BOARD OF APPEALS

Wednesday, December 6, 2023

P&Z STAFF REPORT

Case: **V23-0033 – 0 Zeblin Road**
Staff Contact: LaQuita Williams (lwilliams@sandyspringsga.gov)
Report Date: October 25, 2023

PROPOSED DEVELOPMENT

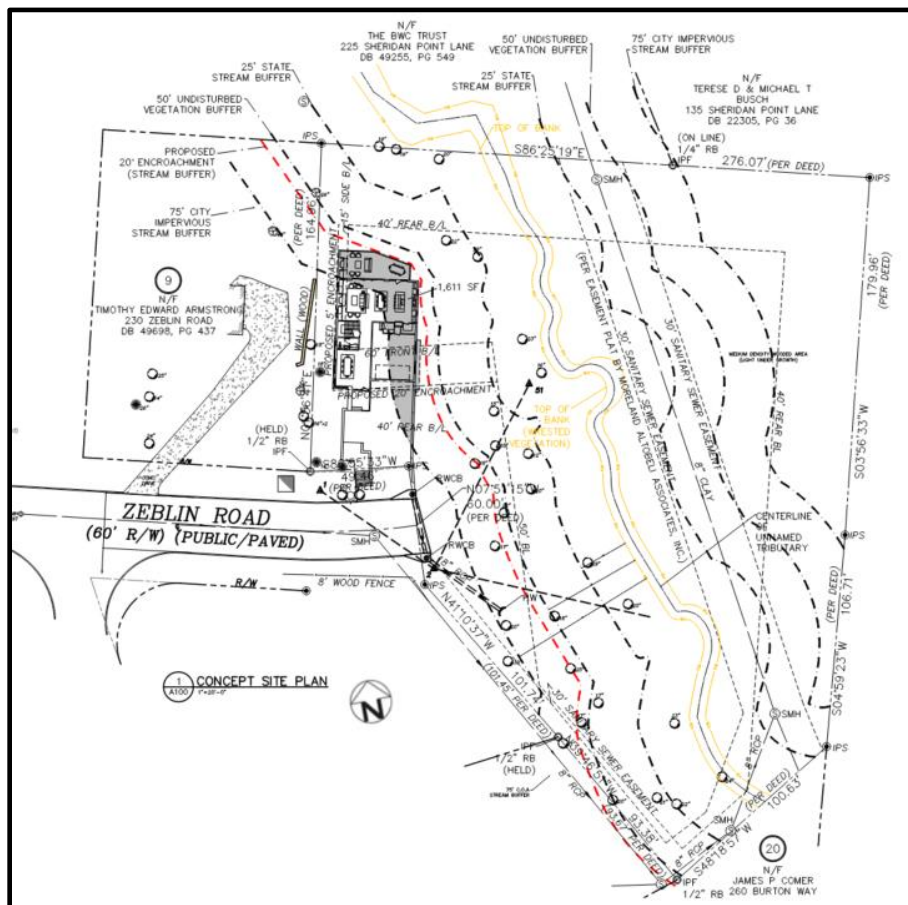
SITE ENGINEERING AND TRANSPORTATION COMMENTS: 1. Stairs are shown within right-of-way. These must be located on the site property. 2. The driveway is shown where there are existing catch basins. Driveway apron cannot be placed where catch basin is. Site plan shall show how this will be addressed. 3. Plan appears to show retaining wall being constructed within right-of-way. Remove walls from right-of-way. 4. Due to limited site space, conceptual plan needs to address stormwater management for this site, including proposed impervious area. 5. Project site has future conditions floodplain. Site plan needs to address the location/limits of the future floodplain. 6. Topography on site is steep. Show contours on the site plan. GIS may be used for conceptual purposes, field run is preferred. 7. Site requires a steep slope analysis in accordance with Section 9.4.2 of the Development Code. 8. Due to steep topography, site plan needs to address retaining walls required and foundation wall requirements. 9. Concept plan should show how sanitary sewer service will be achieved due to topographic limitations. Will service be required to cross the stream? Or, can service be achieved with a connection in the street? 10. Dimension distance to end of road from intersection of Zeblin Rd and Bruton Way.

Label stream buffers correctly. The 25-ft State Water Stream Buffer, the 50-ft City Stream Buffer, and the 75-ft Impervious Setback. A greater encroachment into the side setback is suggested, in order to decrease the encroachment into the stream buffers. Provide a transverse section through the house and the site showing how the house will sit on the site and indicating what structural strategy will be used for supporting the house, considering the challenging topographical conditions. Based on topographical information on the City G.I.S. maps, the site drops from 998 at the front left corner to about 948 at the stream. Staff also discussed the idea of locating the garage on the left side of the house, since it would probably be easier to get the driveway in to the garage. The garage could be embedded into the hillside, too, whereas it would probably not be desirable for the dining room to be set into the hillside. If the dining room were on the right side of the house, it would have better views. Provide spot elevations for corners of proposed driveway.

1. This project shall meet the full requirements for Stormwater Management meeting Division 9.6 of the Development Code, including Water Quality, Channel Protection, Overbank Flooding and Extreme Flooding up to and including the 100-year design storm event regardless of the quantity of new, replaced or created impervious surfaces.
2. Provide a planting plan that meets the State Water Buffer Restoration Standards (Tech. Manual Sec. 1.E.) for stabilization of the disturbance in the impervious setback.
3. The construction be substantially similar to the submitted site plan unless instructed to provide modifications per the City Engineer.

PROPOSED DEVELOPMENT

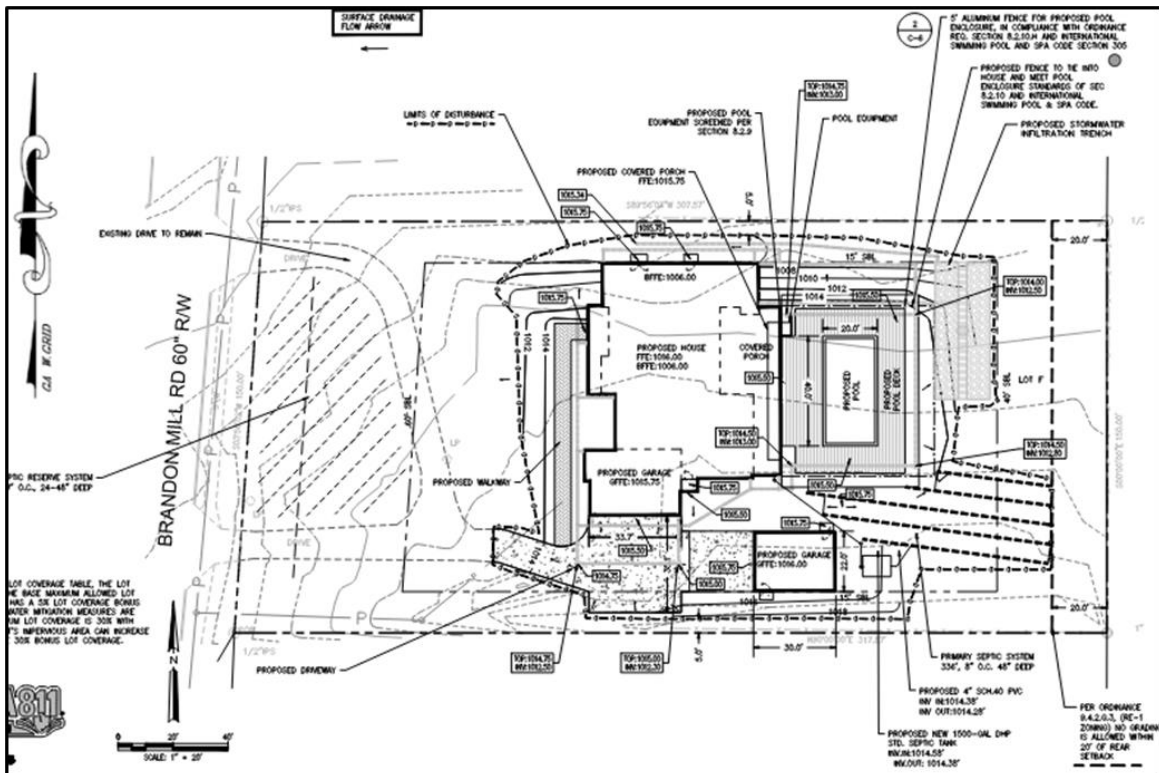
The property has two existing curb cuts and driveways that previously served a now demolished home. The construction of a new home necessitates the adherence to the prevailing Development Code which prohibits more than one curb cut per parcel on Brandon Mill. If the previous home remained, adherence to the existing development code standards would not have been triggered, as the driveways would have been categorized as a legal nonconforming site element.

Technical Manual Section 3.B.3.g States: Not more than one private curb cut may be located on any one street frontage for any one dwelling where the street is classified as a collector or higher order street. Brandon Mill Road is classified as a Collector Street and has a baseline (2017) traffic count of 7,993 vehicles per day. Future traffic counts are estimated to exceed 8987 vehicles per day. Brandon Mill Road is a major north-south connection between Johnson Ferry and Dalrymple Road serving numerous residential subdivisions in the area. A reduction of access points provides safer conditions for the overall traveling public. Based on the Soil Survey performed by EnviroSoil the whole entirety of this lot contains Cecil Soils. Cecil Soils have a soil suitability Code of A which states "These soils are suitable for installation of on-site systems with proper system design, installation and maintenance." Removal of the existing driveway by lessor invasive measures would not be prohibitive to installation of the reserve septic field, if or when that becomes necessary. Additionally, proper care of the primary drain field can result in a life expectancy exceeding 40 years. City Engineer recommends denial of this request.

he driveway can be reduced to one curb cut with minimal impact to the critical root zones of the trees through the implementation of BMPs or the hand removal of the existing driveway. Additionally, the current plan shows the trees as being removed in the future through the potential installation of a reserve septic field in the same area. If the trees are intended to be preserved long-term, the reserve septic field should be shifted to another location on the property.

Two curb cuts are not allowed on Brandon Mill Road. This is for the safety of the thousands of drivers who pass through there on a regular basis. Removing one end of the driveway by hand will only cause minimal damage to the tree roots. The trees would be removed anyway to install additional septic field. According to the City Engineer there are other suitable areas on the site for septic fields. Simply keeping both curb cuts does not preserve the character of the neighborhood. If the builder wanted to do that successfully he would not be demolishing the house to build a much larger house.

DEPARTMENT OF COMMUNITY DEVELOPMENT RECOMMENDATIONS
Following review, and based on the findings, staff recommends Denial of Variance V23-0042 , a request for a Variance from Technical Manual Section 3 B.3.g. and Development Code Section 6.5.2.A.1. to allow more than one existing curb cut to remain on a single lot off a collector road as part of a new construction project.
